PROPOSAL REQUEST

PROJECT:	LXT Hangar 2 Eastside Development	PROPOSAL NO:	11
OWNER:	City of Lee's Summit	DATE OF ISSUANCE:	04/11/25
TO:	Fogel-Anderson Construction 1212 E. 8th Street Kansas City, MO. 64106	ARCHITECT:	Wellner Architects, Inc. 1627 Main Street, #100 Kansas City, MO 64108
COPY:	File		
CONTRACT FOR:	General Construction	ARCHITECT'S PROJECT:	2219
CONTRACT DATE:

Item 1. SHEET A610 FINISH SCHEDULE:

A610

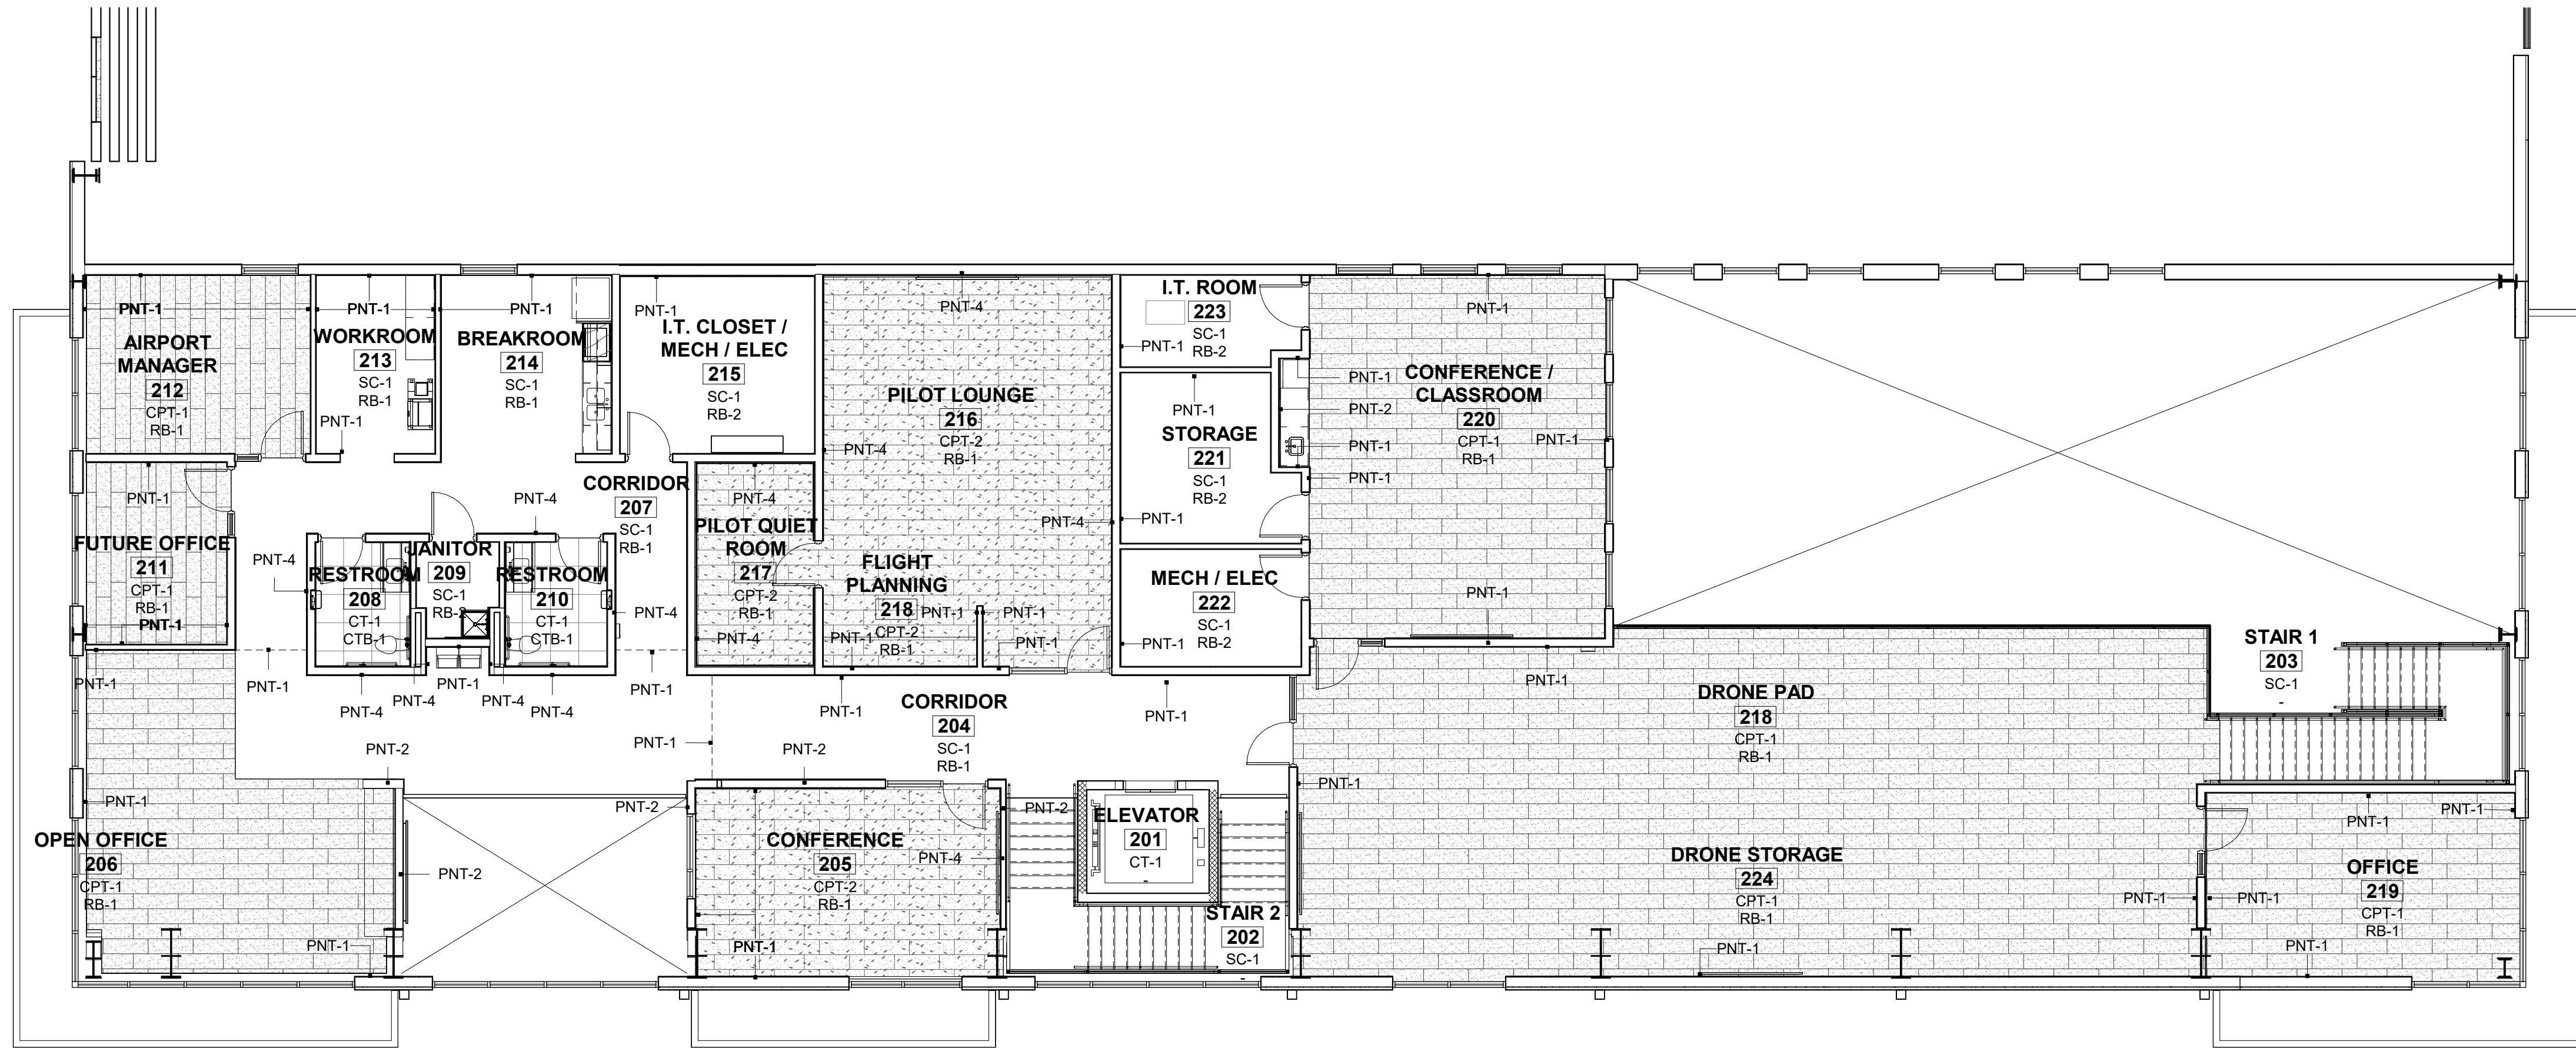
FINISH SCHEDULE rm 113 ASSISTANT MANAGER **Revise** the floor finish from sealed concrete SC-1 to carpet CPT-1

A611

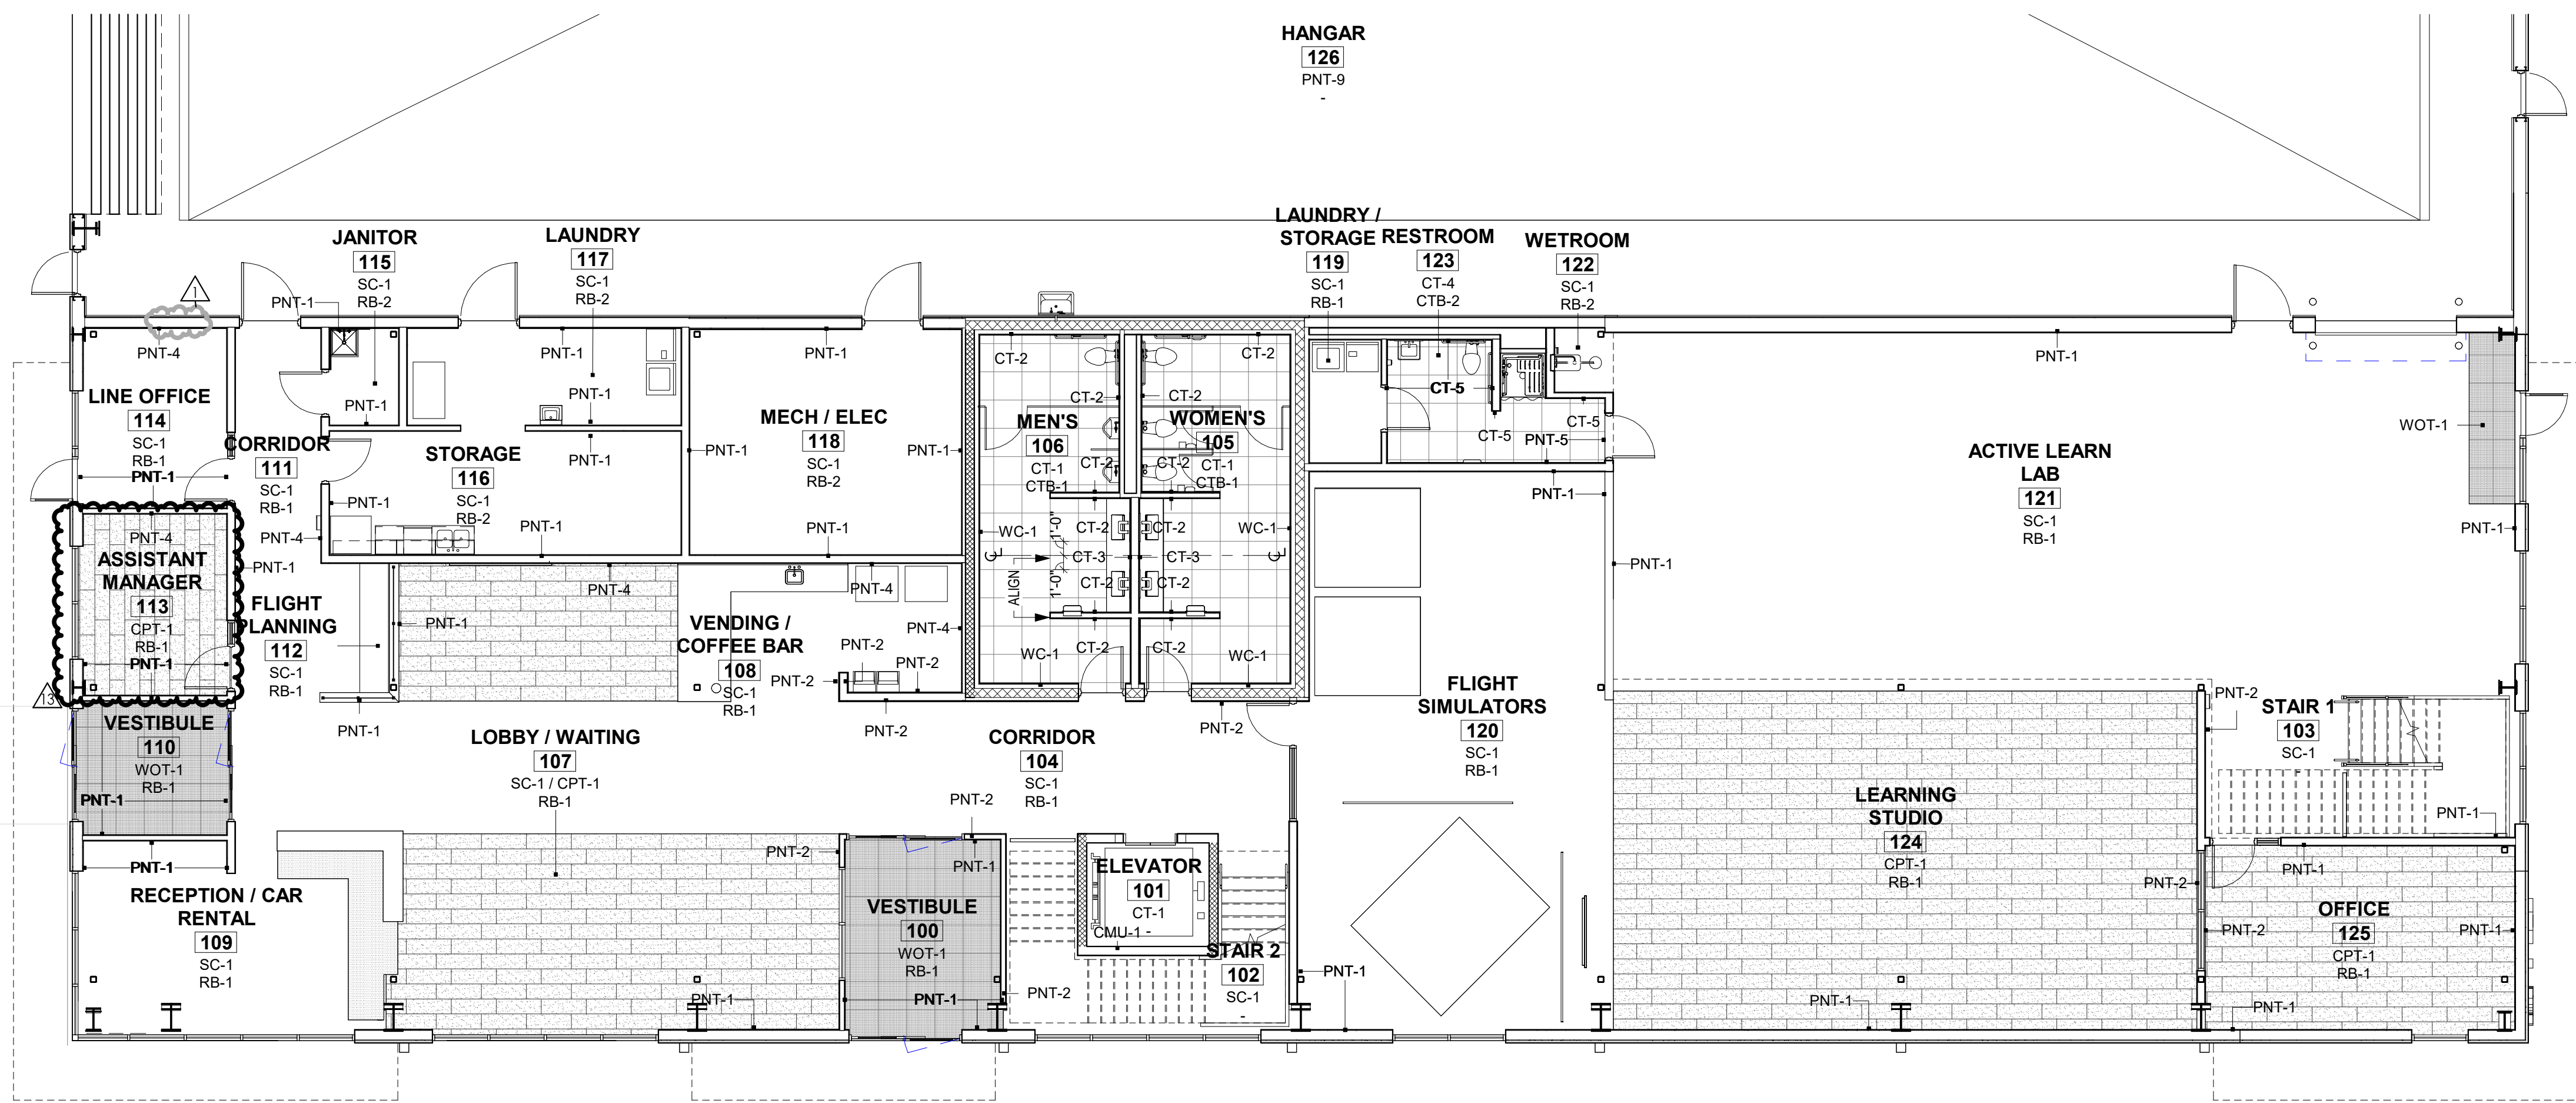
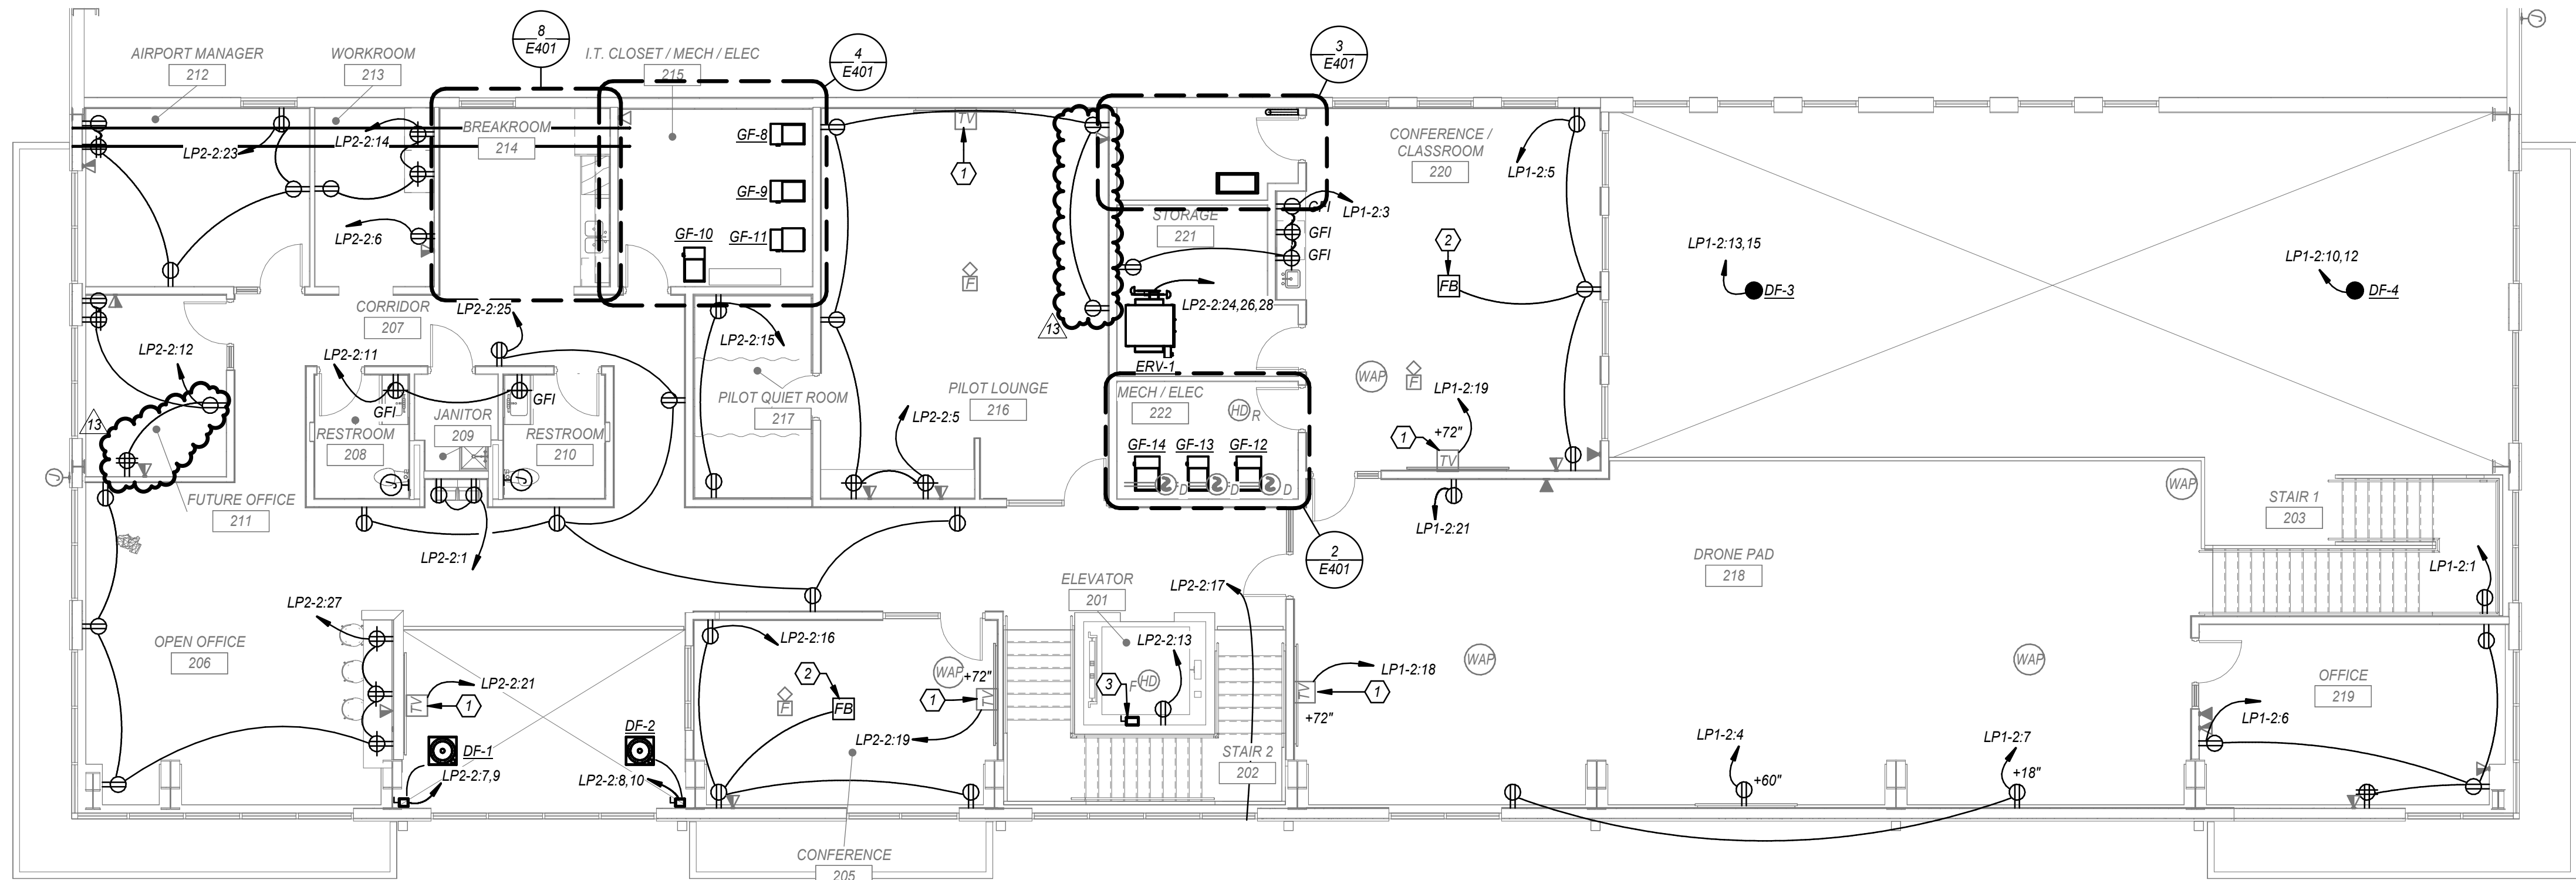
Item 2. SHEET E611 FINISH FLOOR PLANS:

FINISH FLOOR PLAN - LEVEL 1 ASSISTANT MANAGER rm 1113 **Revise** the floor finish from sealed concrete SC-1 to carpet CPT-1
